Index 711-002 Bicycle Markings

COMMENTARY

MUTCD 11th Edition has removed the helmeted bicyclist symbol and therefore all FDOT Standards and Criteria must be updated accordingly.

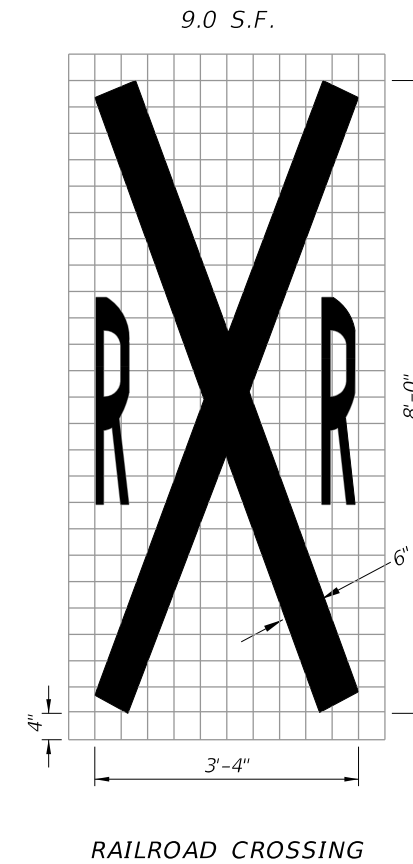
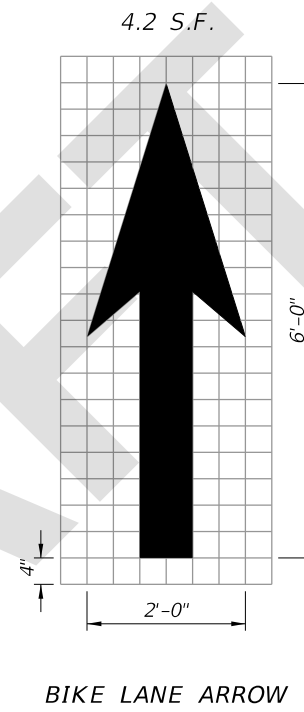
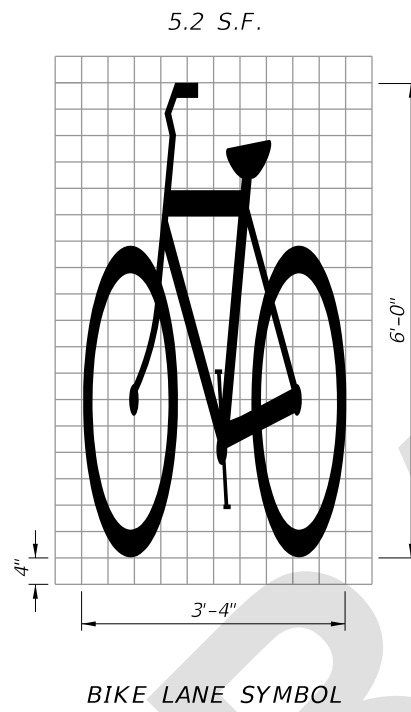
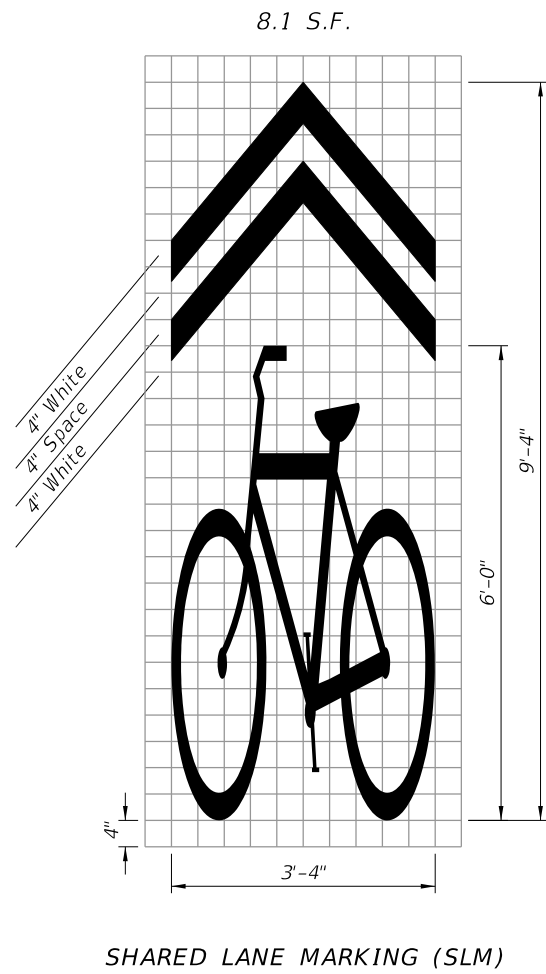
COMMENT: The helmeted bicyclist is removed and the bicycle is added. The SF remains the same. Based on the Shared Lane Marking, the SF should be closer to 5 SF rather than the 6.3 SF shown.

RESPONSE: Thanks for your comment. Great catch - will correct accordingly.

CHANGE MADE TO INDEX: Yes.
